FAIRFAX COUNTY, VIRGINIA

MEMORANDUM

SUBJECT: Staff Analysis of Conceptual Plan 86-C-121-12: Wink Development,
LLC, Reston Section 89, Block 3

RESTON TOWN CENTER CONCEPT PLAN & VARIANCE PLAN WINWOOD CHILDREN'S CENTER RESTON SECTION 89 BLOCK 3 HUNTER MILL DISTRICT FAIRFAX COUNTY, VIRGINIA

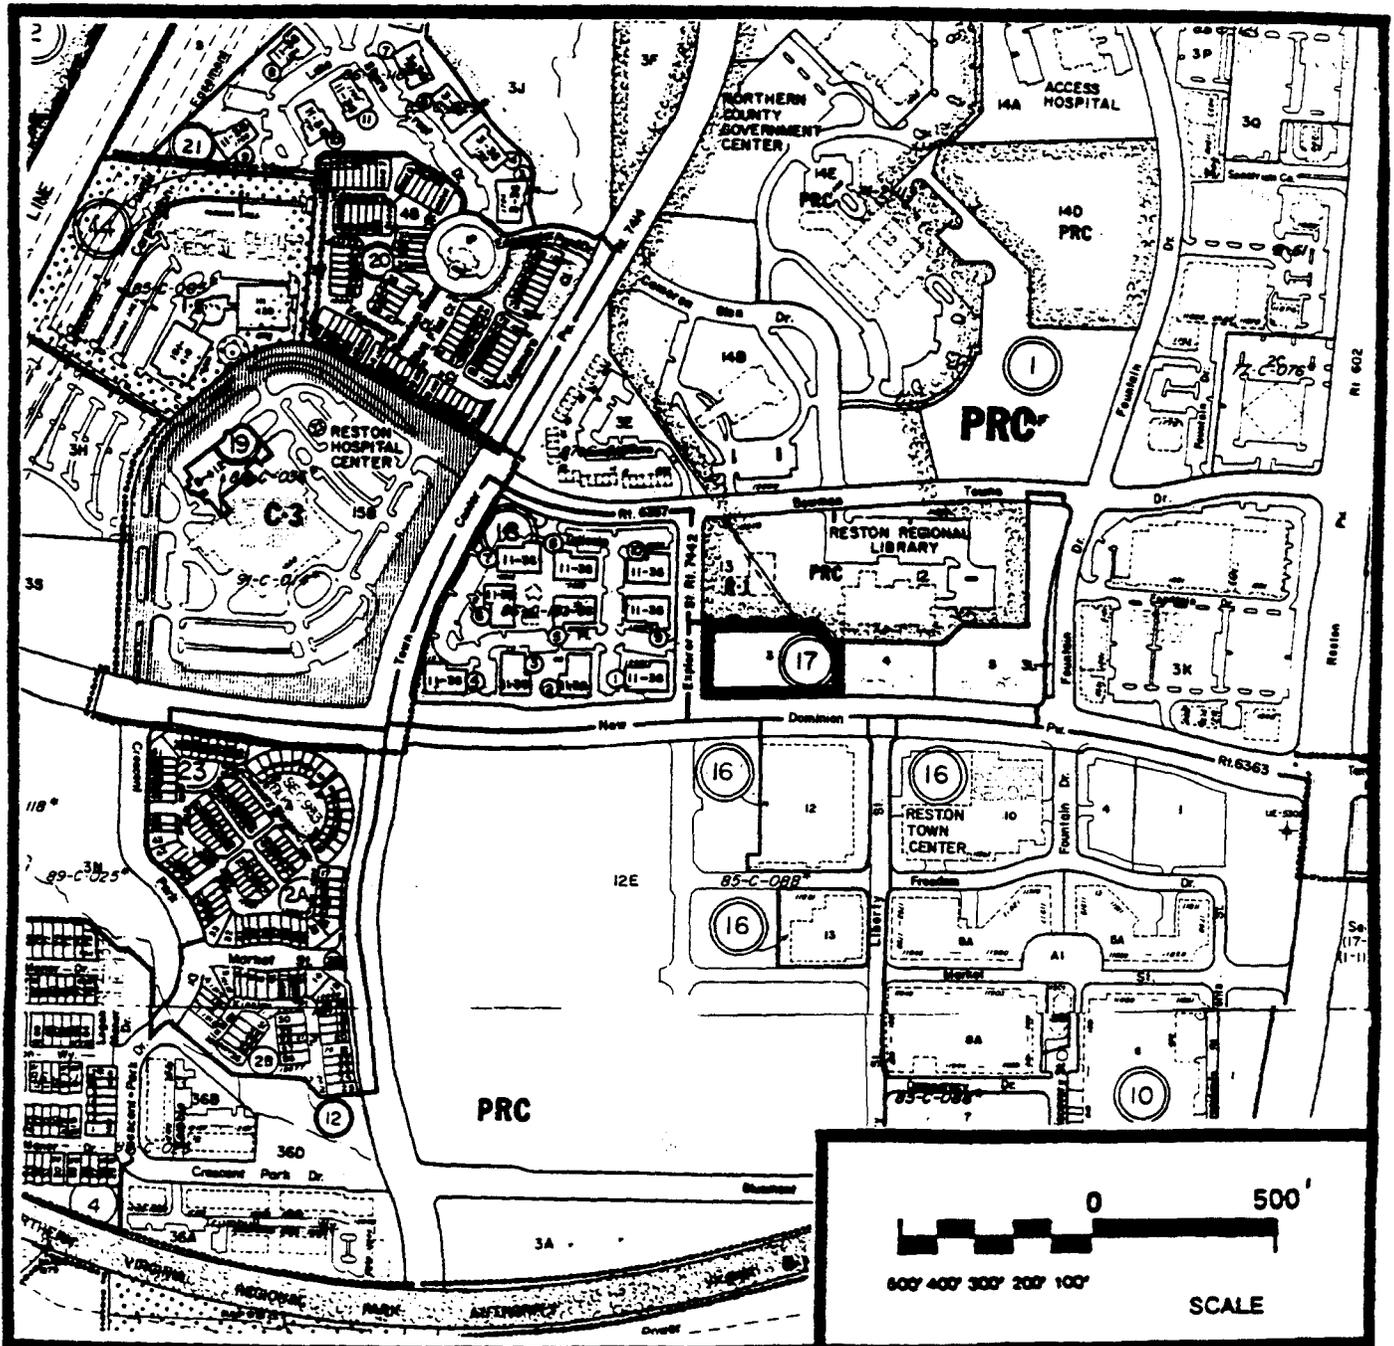
To place a six foot tall fence along New Dominion Parkway will require the approval of a variance from the Board of Zoning Appeals. Under the Zoning Ordinance the maximum fence height permitted in a front yard is four (4) feet. A note has been included on the Concept Plan that the height of the fence may be increased to six feet subject to the approval of a variance.

Much of the property is characterized by hardwood forest cover. Several large oak trees are present on the site. In the original submission, the conceptual plan indicated that most, if not all, of the hardwood forest area on the site will be cleared. A note on the conceptual plan indicated that 50 parking spaces will be provided while only 29 are required.

In response to staff's concerns, the applicant submitted a revised Concept Plan with a reduction of five parking spaces. In addition, staff from the Urban Forestry Branch has met on site with representatives to discuss the preservation of selected trees. The revised CP also contains the landscape plan that reflects recommendations of the Urban Forester with regards to tree save.

In response to staff's concern, the applicant has proposed a six foot board-on-board fence, subject to BZA approval, at the edge of the toddler play area which abuts the front yard created by New Dominion Parkway to enhance noise mitigation efforts. This fence will be placed several feet behind the four foot masonry fence; in addition, plantings will be placed between the two fences, as indicated on the landscape plan.
